SUBJECT: Pekin Municipal Airport,
Pekin, Tazewell County, Illinois
Replace Airfield Electrical Vault, Replace Beacon Unit and Tower,
Relocate Regulator; Replace Remaining Airfield Lighting, Signage and
Navigational Aids
Illinois Project No.: C15-4578
SBG Project No.: 3-17-SBGP-133/139
Contract No. PN010
Item No. 01A, November 17, 2017 Letting
Addendum A

NOTICE TO PROSPECTIVE BIDDERS

REPLACE AIRFIELD
ELECTRICAL VAULT,
REPLACE BEACON UNIT
AND TOWER; RELOCATE
REGULATOR; REPLACE
REMAINING AIRFIELD
LIGHTING, SIGNAGE AND
NAVIGATIONAL AIDS

PROPOSED
ELECTRICAL ONE
LINE FOR VAULT AND
AIRFIELD - SHEET 2

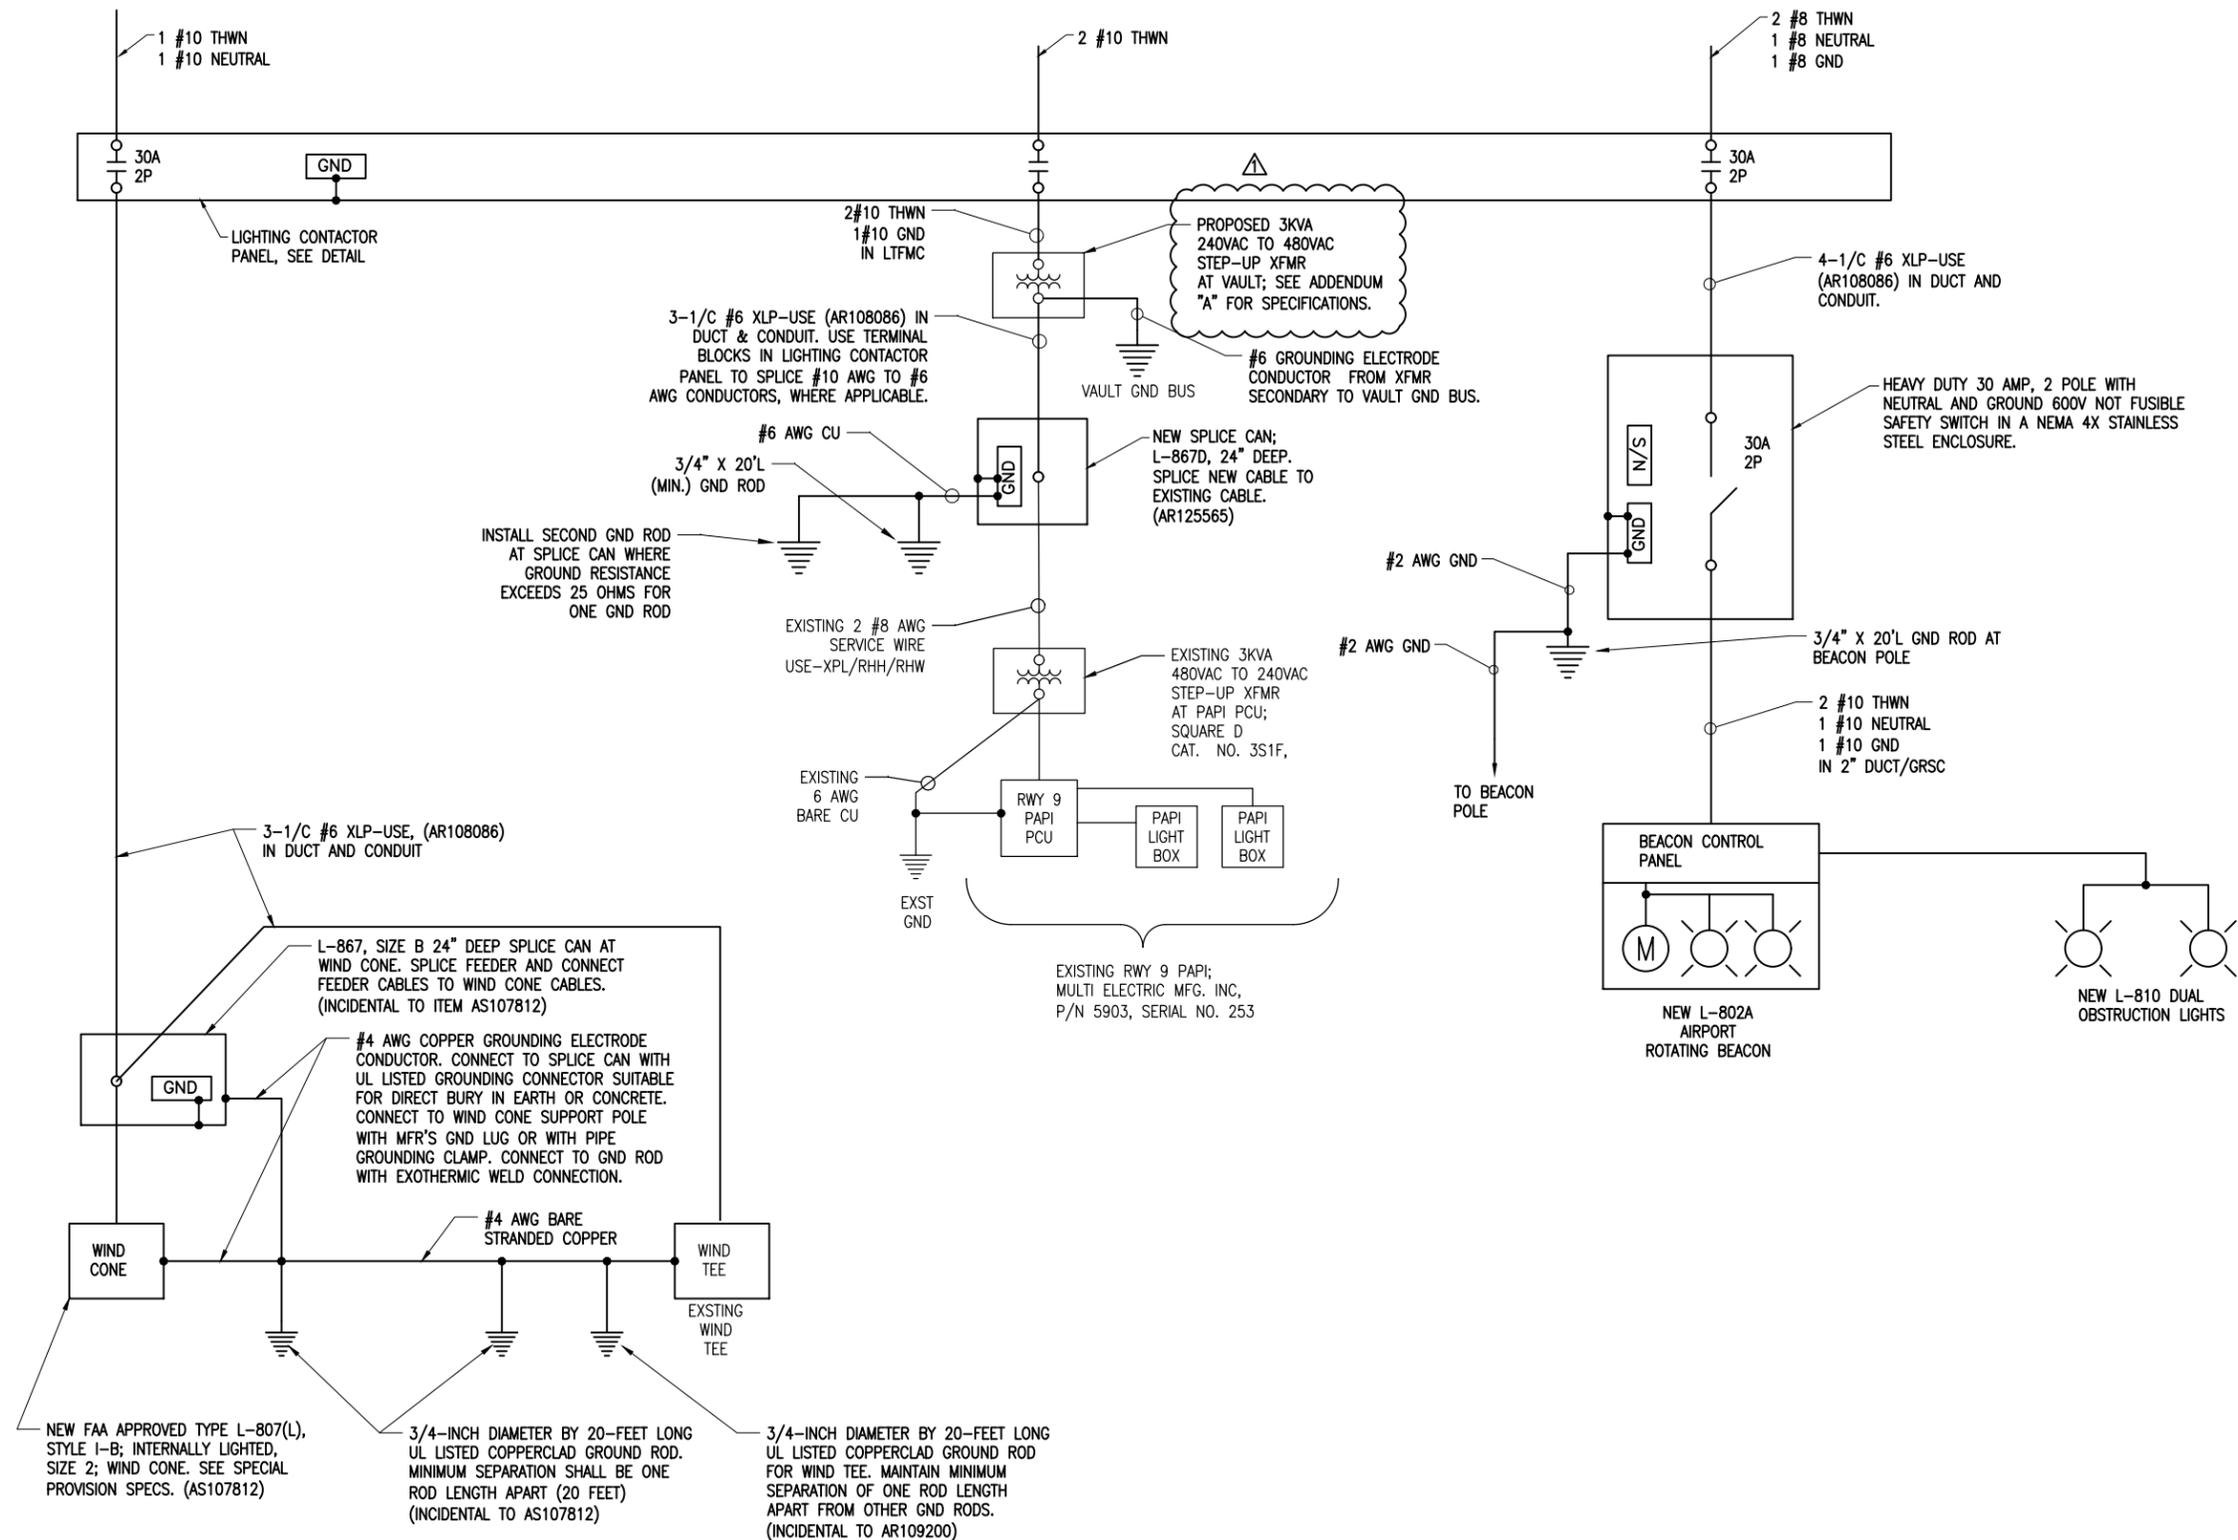
Plan Sheet 43 is updated to show a proposed 3 KVA, 240 VAC to 480 VAC step-up transformer for the Runway 9 PAPI, 480 VAC feeder circuit.
